## V2500-A1/A5 SERIES NACELLE SERVICE BULLETIN

This document transmits Revision 1 to Service Bulletin NV2500-78-0199

# V2500-NAC-78-0199

NACELLE – THRUST REVERSER – AFT SUPPORT RING REPLACEMENT – BLANK CASCADE REPLACEMENT  
– ACTUATOR COVER REPLACEMENT

Not subject to the EAR per 15 C.F.R. Chapter 1, Part 734.3(b)(3).

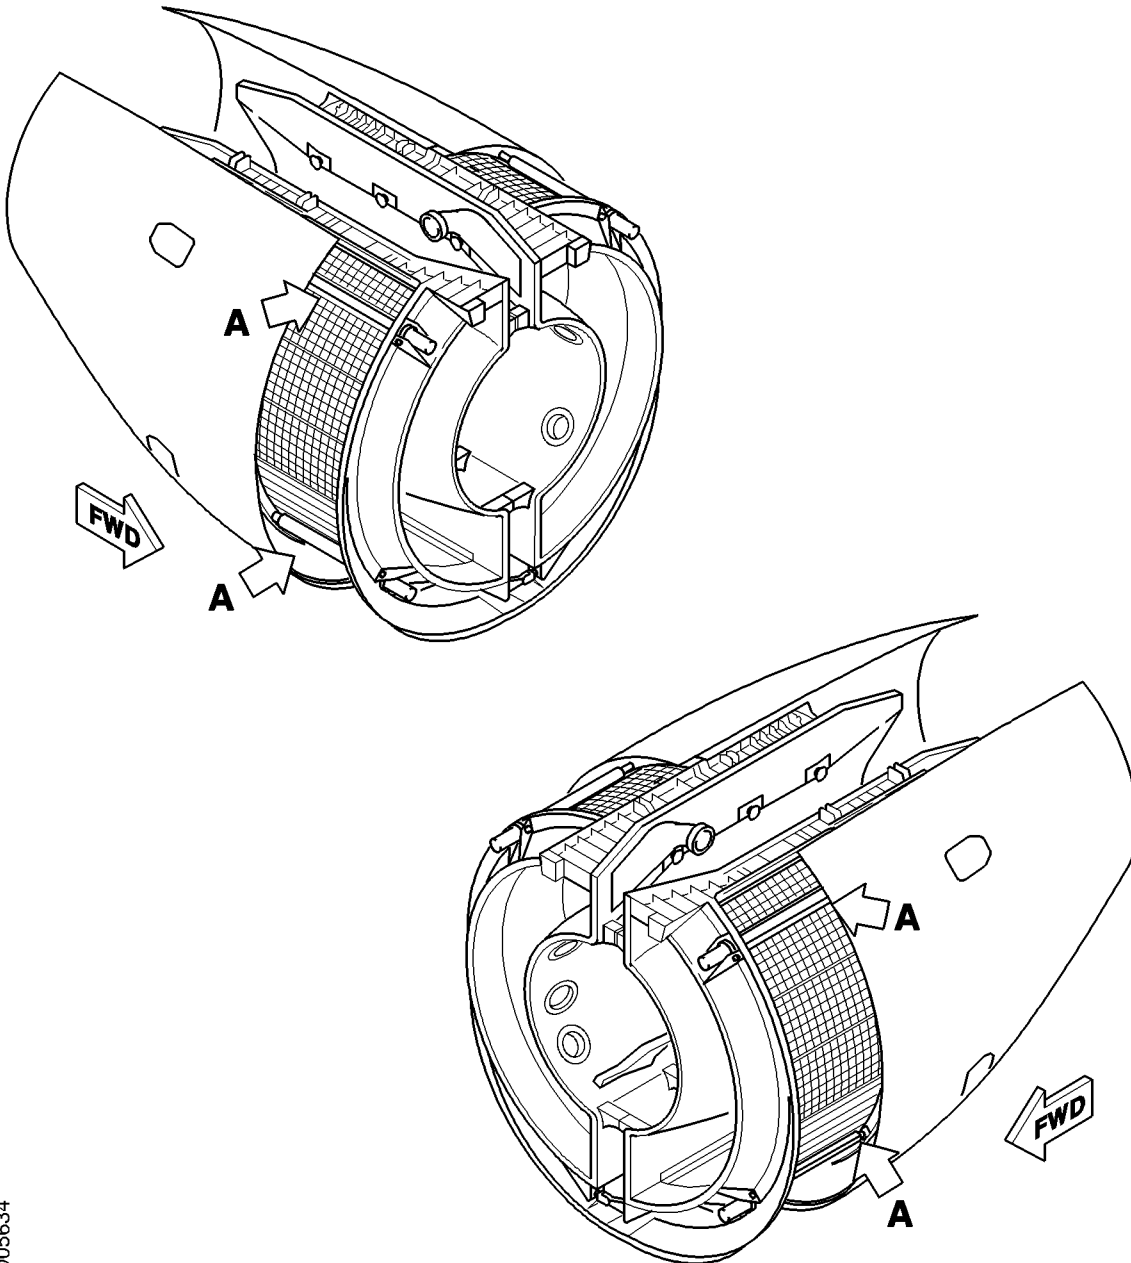
- R (14) Replace the blank cascades. Refer to Figure 3. Install the new blank  
R cascades. Refer to the Aircraft Maintenance Manual, TASK 78-32-19-400-010.

- R NOTE: The attach hardware for installation of a blank cascade on the new  
R aft support ring is different from that required for installation  
R on the old aft support ring. Refer to Figure 3 for the proper  
R attach hardware.

Replace the Actuator Covers  
Figure 4 (Sheet 1)

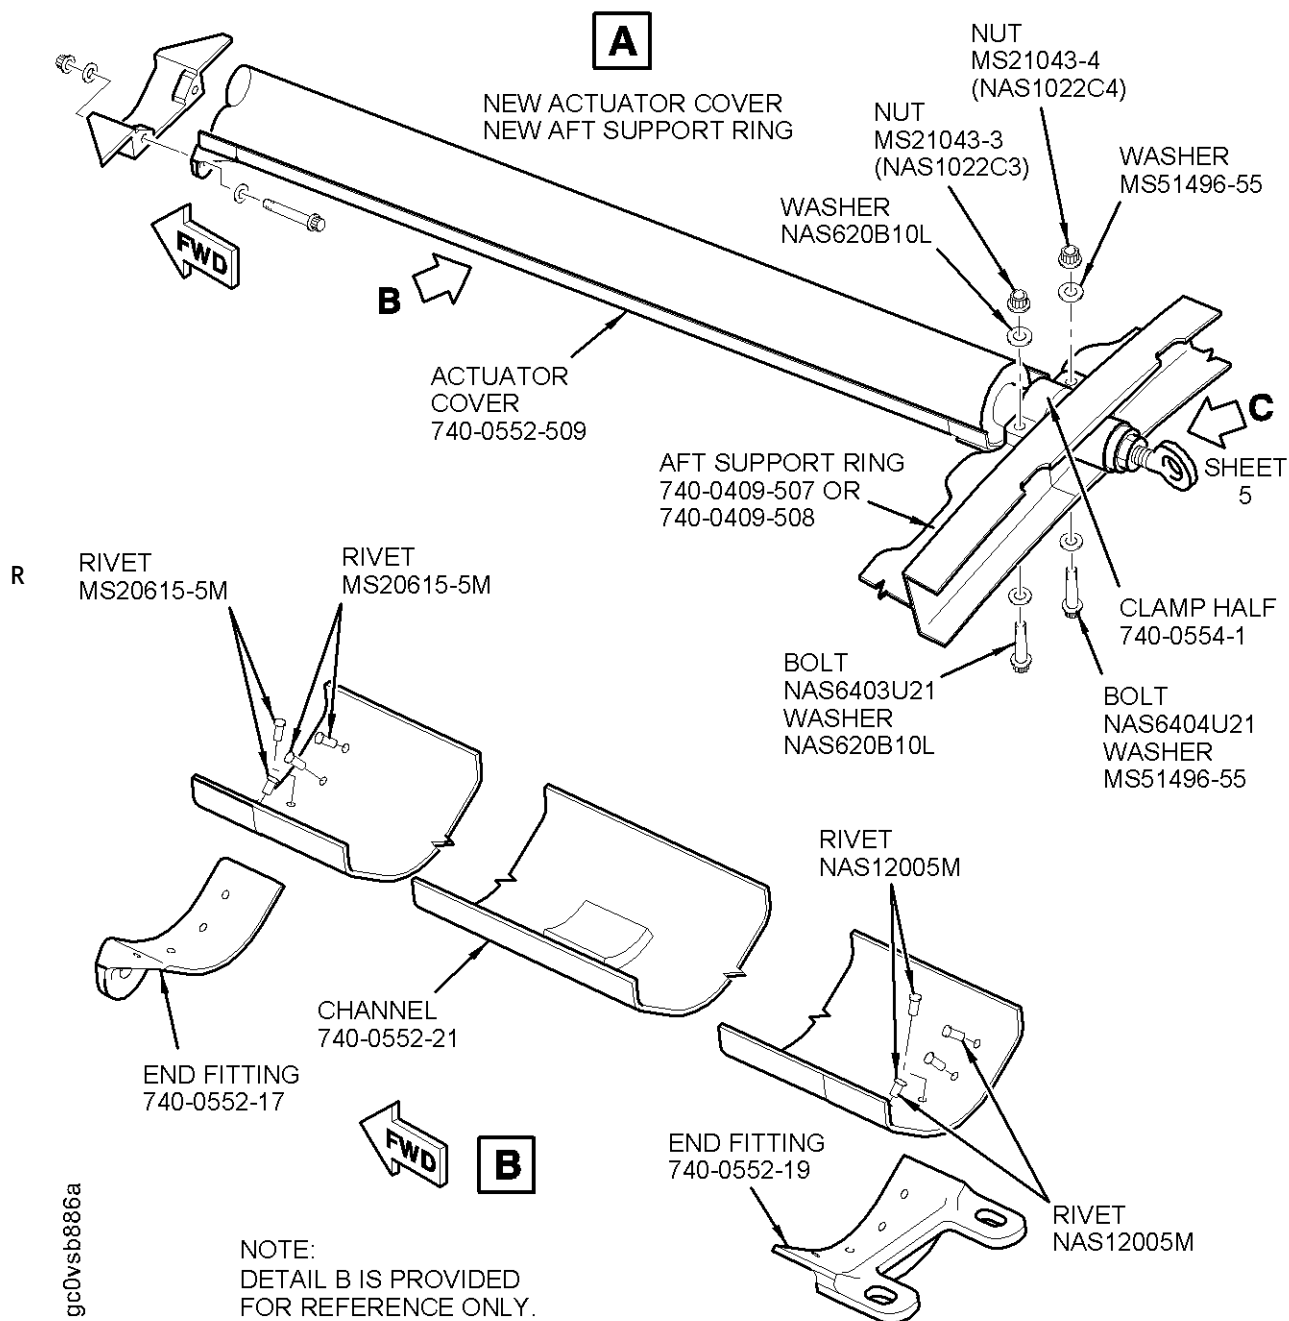
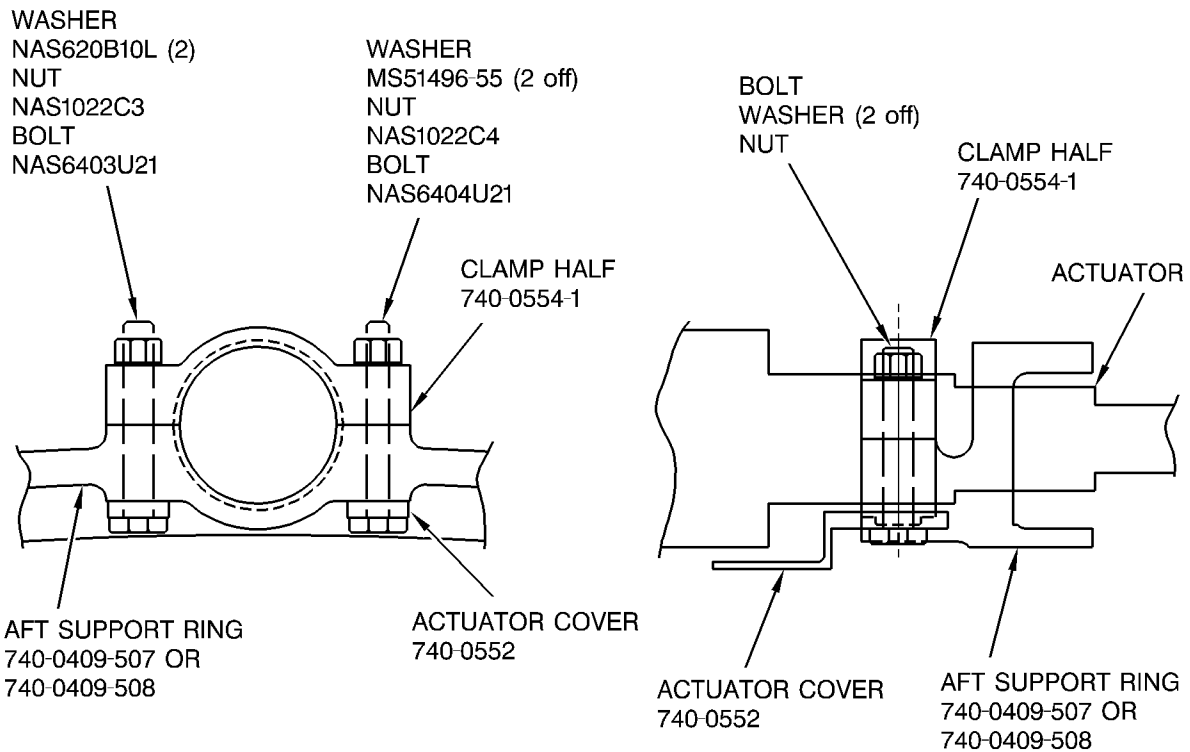
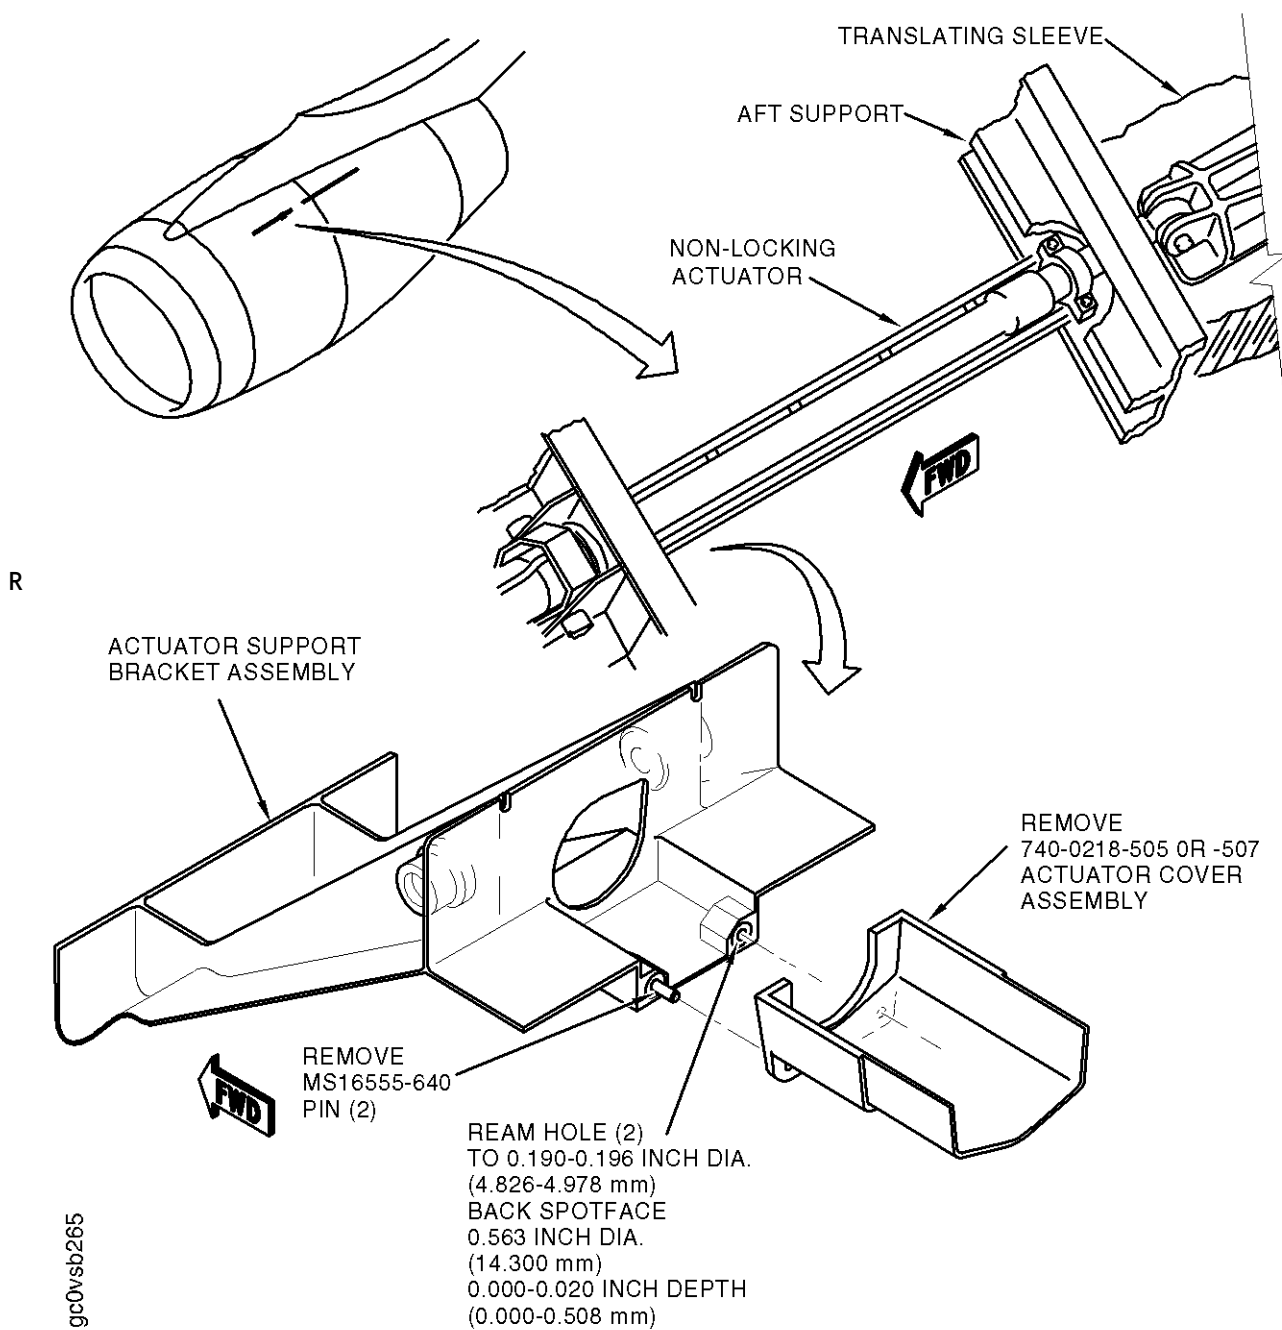
(11) Replace the actuator covers. Refer to Figure 4 and 5. Install the new actuator covers using the appropriate hardware.

**NOTE:** The attach hardware for installation of the actuator cover on the new aft support ring is different from that required for installation on the old aft support ring. Refer to Figure 4 for the proper attach hardware.

Remove Actuator Cover and Ream Holes  
Figure 5 (Sheet 1)

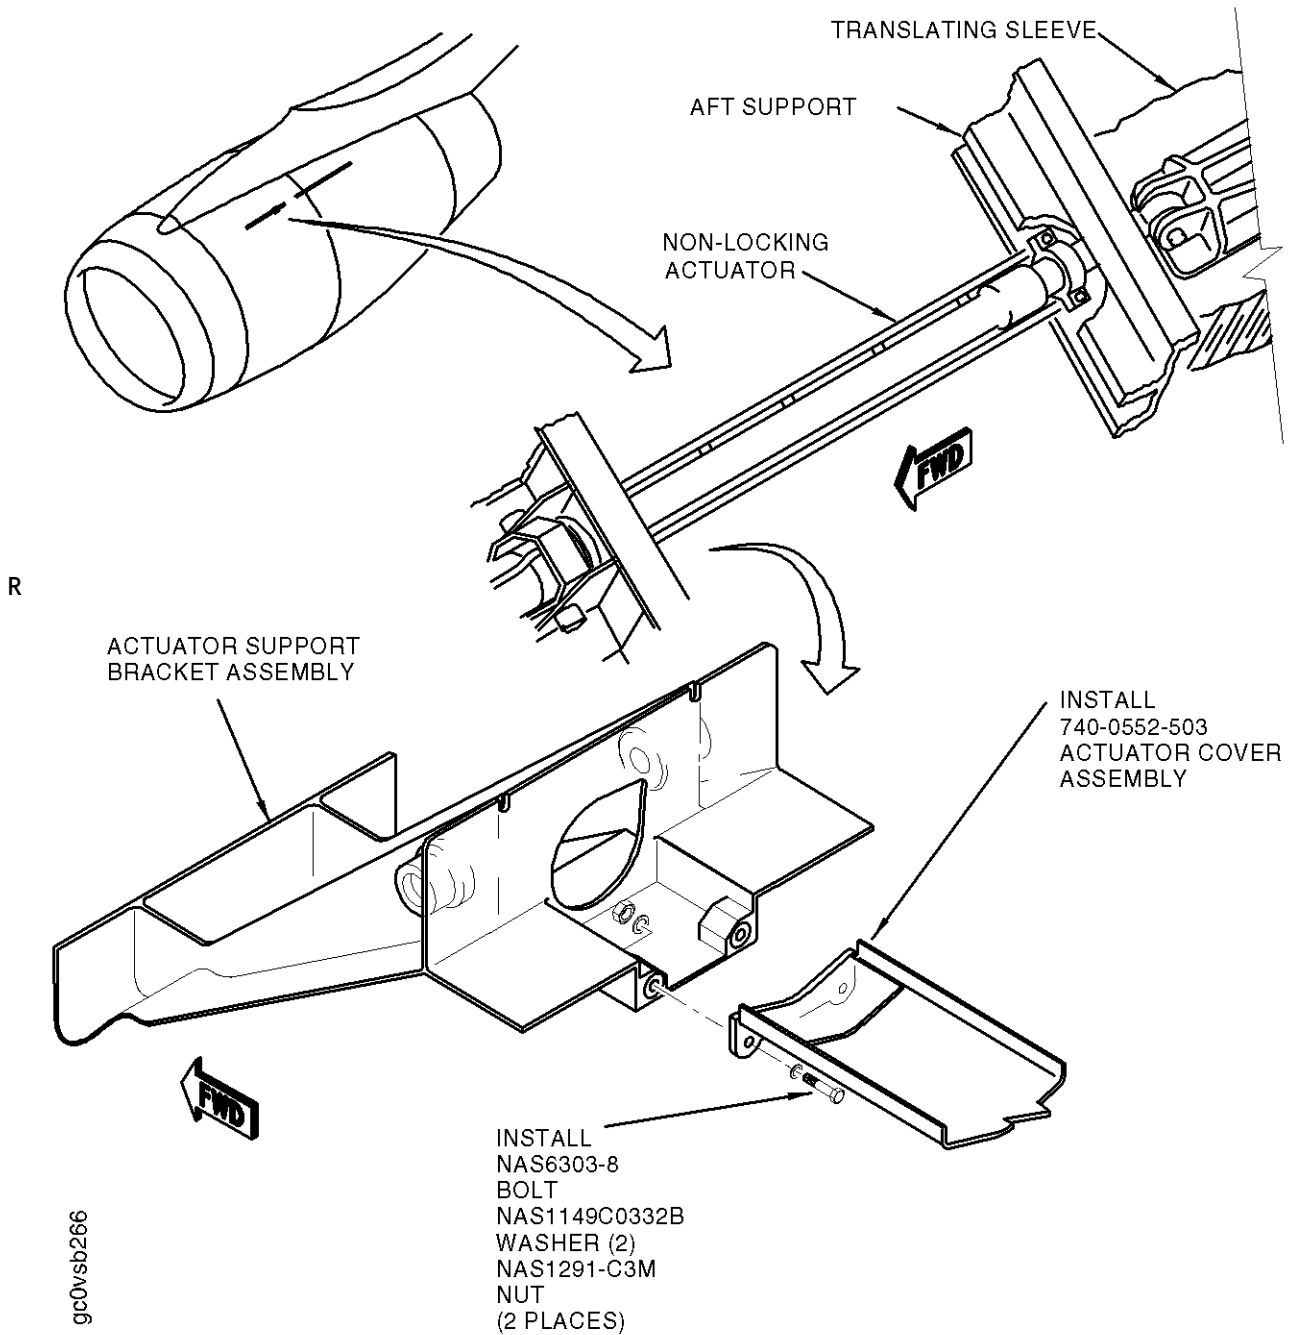
- R (i) Remove two MS16555-640 pins from actuator support bracket  
R assembly. Discard these parts. (Refer to Figure 5, Sheet 1).

(ii) Ream the two holes in the actuator support bracket assembly to 0.190 - 0.196 inches (4,83 - 4,98 mm).

(iii) Back spotface forward side of the holes to 0.563 inch diameter (14,300 mm) and to a depth of 0.000 - 0.020 inch (0,000 - 0,508 mm).
